COUNCIL ASSESSMENT REPORT

SOUTHERN REGIONAL PLANNING PANEL

PANEL REFERENCE & DA NUMBER	PPSSTH-247 – DA0593/23
PROPOSAL	Demolition and construction of a Residential Flat Building (60) units (2 x 1 bed; 12 x 2 bed; 42 x 3 bed and 4 x 4 bed) including basement car parking for 88 vehicles (plus 3 car wash bays)
ADDRESS	Lot 1 DP 1135117 [20 Heradale Parade Batemans Bay]
APPLICANT	M Alexander-Hatziplis
OWNER	Edam Properties Pty Ltd
DA LODGEMENT DATE	17/5/23
APPLICATION TYPE (DA, Concept DA, CROWN DA, INTEGRATED, DESIGNATED)	Nominated Integrated (Water NSW)
REGIONALLY SIGNIFICANT CRITERIA	Clause 4, Schedule 6 of <i>State Environmental Planning Policy (Planning Systems) 2021</i> : Regionally significant development – General development where the CIV exceeds \$30,000,000
CIV	\$37,267,709 (incl. GST); \$33,879,736 (excl. GST)
CLAUSE 4.6 REQUESTS	<u>Cl.4.3. Height of Buildings</u> The proposal has building heights varying between 12.18m – 14.141m (Building A); 13.2m – 13.88m (Building B); 11.92m – 14.6m (Building C) on a site with a height limit of between 11.5m and 12.5m.

RECOMMENDATION	Approval
DRAFT CONDITIONS TO APPLICANT	Yes
SCHEDULED MEETING DATE	28 January 2025
PLAN VERSION	-
PREPA

Figure 20: architectural plans –extract from Height of buildings plan/s

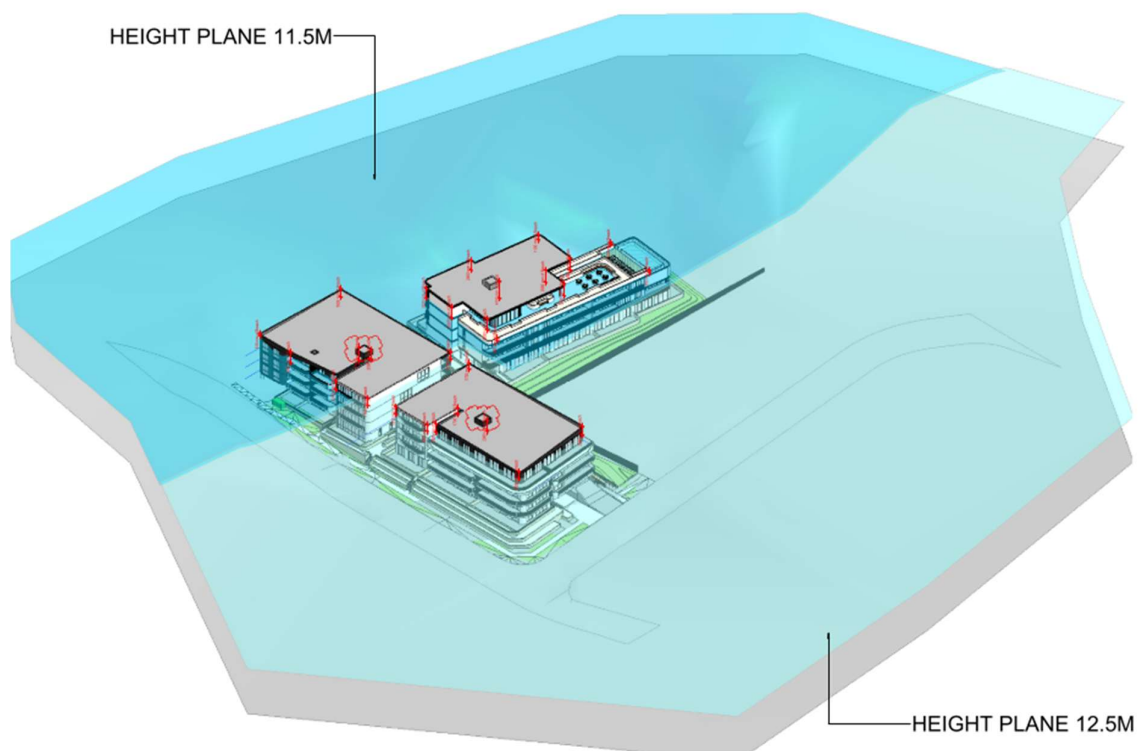
The proposal involves a variation to the development standard that varies across the site for the three proposed buildings varying:

Building A: 618mm – 3.75m (lift) (*within 11.5m HOB*) 5.3% – 32.6%
 Building B: 1.7m – 2.96m (lift) (*within 12.5m HOB*) 13.6% - 23.68%
 Building C: 420mm – 4.15m (lift) (*within 11.5m HOB*) 3.7% - 36%

Buildings A and B present to Bavarde Avenue and are proposed to have the same overall building height of RL16.030m for the roof and RL 17.230m for the lift. Due to the split Height of Buildings limit for the site (12.5m at the corner and 11.5m at the western part of the site) this results in differing building height variations. Building C is proposed to have an overall building height of RL16.200m and lift overrun of RL17.4m, being slightly higher than buildings A and B i.e. 170mm for the main roof height than Buildings A and B.

The site is located within an area affected by flooding site constraints which has resulted in raised finished floor levels for the ground floor of all proposed buildings and subsequently affecting the overall building heights. The flood planning level for the site is identified as 3.43m AHD for Building A&B and FPL of 3.60m AHD for Building C with existing natural ground levels varying across the site from a range of RL1.87m – RL 2.14m AHD within the development footprint area i.e. requiring raised ground floor levels of 1.73m for building C and 1.26m for Buildings A & B.

Figure 22: A Council planner mark up of 'yellow' area of proposed building heights and location of building height upslope i.e approximate RL16.2m AHD

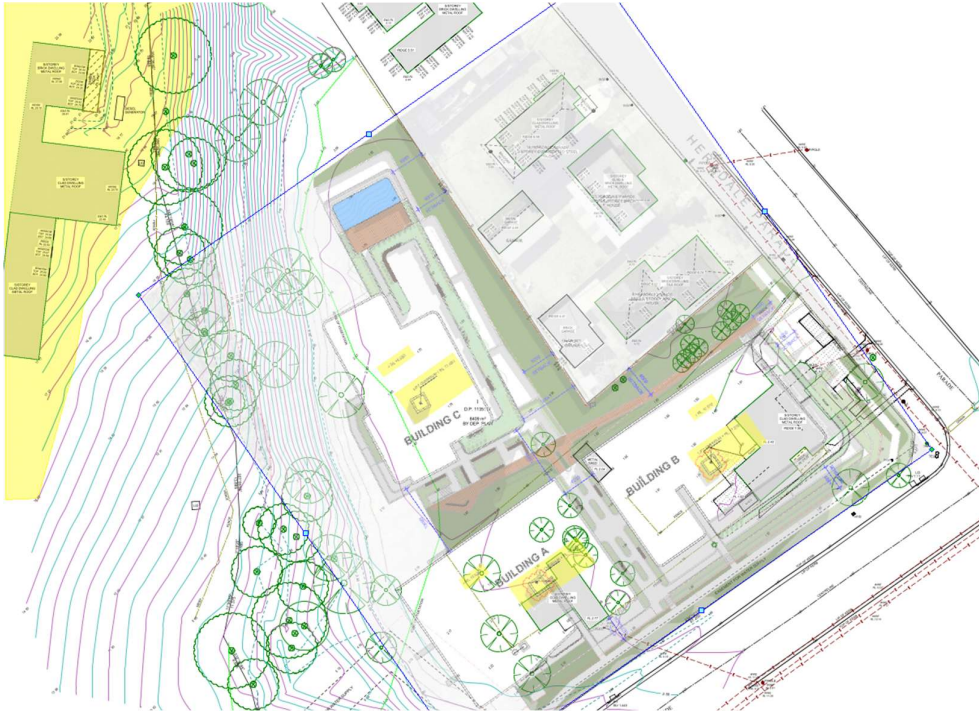
Views - An assessment of the proposal in relation to the submitted survey plans identifies the hospital site located upslope to the west retains existing views.

This is consistent with the Greater Batemans Bay Structure Plan scenic protection directions which requires development to be designed and located to protect and enhance major vistas, view corridors and areas of scenic protection. This includes protecting views from the hospital site and vicinity located upslope to the west.

The proposed development removes a minor portion of the filtered coastline views currently afforded to dwellings along Bavarde Avenue which are located upslope. These dwelling views are currently screened by treed vegetation to the north and contain limited views along Bavarde Ave to the north-east. Existing views enjoyed by residents on Herarde Street have resulted from the undeveloped nature of the subject site, a site which allows development under current planning controls of buildings up to 11.5m and 12.5m respectively. Views would be obscured were the buildings constructed to the building height limit notwithstanding the variation to the height limit proposed. Although there is view loss, it would be unreasonable to assume that the site would not be developed.

Figure 26: Stamped site plan – No. 14 Bavarde Ave – 21/4/70

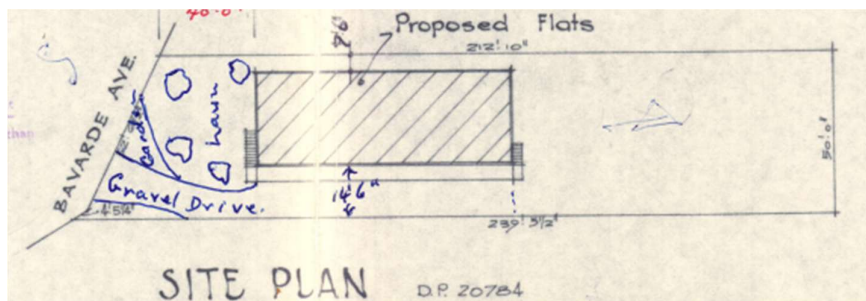
Additional information submitted by the application identified the extent of overshadowing on No. 14 Bavarde Avenue as limited to overshadowing of the building /deck area during the 9am morning period, not evident at the building by 12midday (being confined to the front corner area of the site). Shadow diagrams are provided for a height compliant building and the building height variation proposed, illustrating the greatest impact is in the morning period. The building/s at No. 14 Bavarde Ave receive the minimum 3 hours direct sunlight between 9 am and 3 pm at mid-winter as required under the ADG.

The stamped approved plan for the residential development at No. 14 Bavarde Ave illustrates the POS areas are located within the rear of the site, which continues to receive solar access:

Figure 29: Height of buildings (roof plans) - Applicant plans

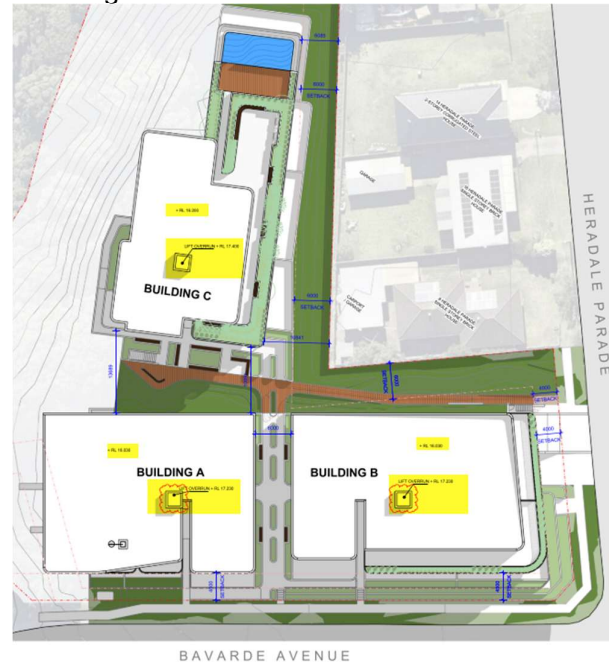
The application proposes a building height variation. The application has been amended during the assessment process to consider the potential impacts on the amenity of adjoining properties from the proposed variation to building height.

Building A & B – roof RL16.030m; lift RL17.230m

Figure 30: Water supply easement – DP

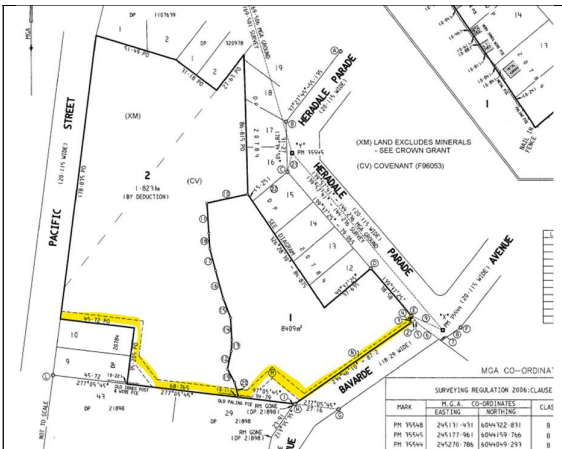
The Eurobodalla Shire Council is the water and sewer authority for this area. The application has amended the building design to provide offsets to the sewer main located within the front setback of the site to Bavarde Avenue and conditions are recommended to allow for impacts on sewer from building and excavation to be minimised throughout the construction process.

The stormwater design has been modified throughout the assessment process to remove the initial design box culvert and raised ground floor (void) area to provide for overland flows to be captured above-ground and diverted through or around the site. Conditions are recommended in relation to stormwater on site detention, treatment and management to minimise potential impacts on residents and adjoining properties. It is requirement prior to any construction certificate being issued to accurately locate the water main and then realign the water supply easement (that is identified on Title running between Pacific Street upslope to the west (the ‘hospital site’) and Heradale Parade to the east) prior to issue of any construction certificate to ensure that any structures are clear of identified easements and that the water main is consistent with the easement location.

Resolution: The issue has been resolved through recommended conditions of consent as outlined in **Attachment A**.
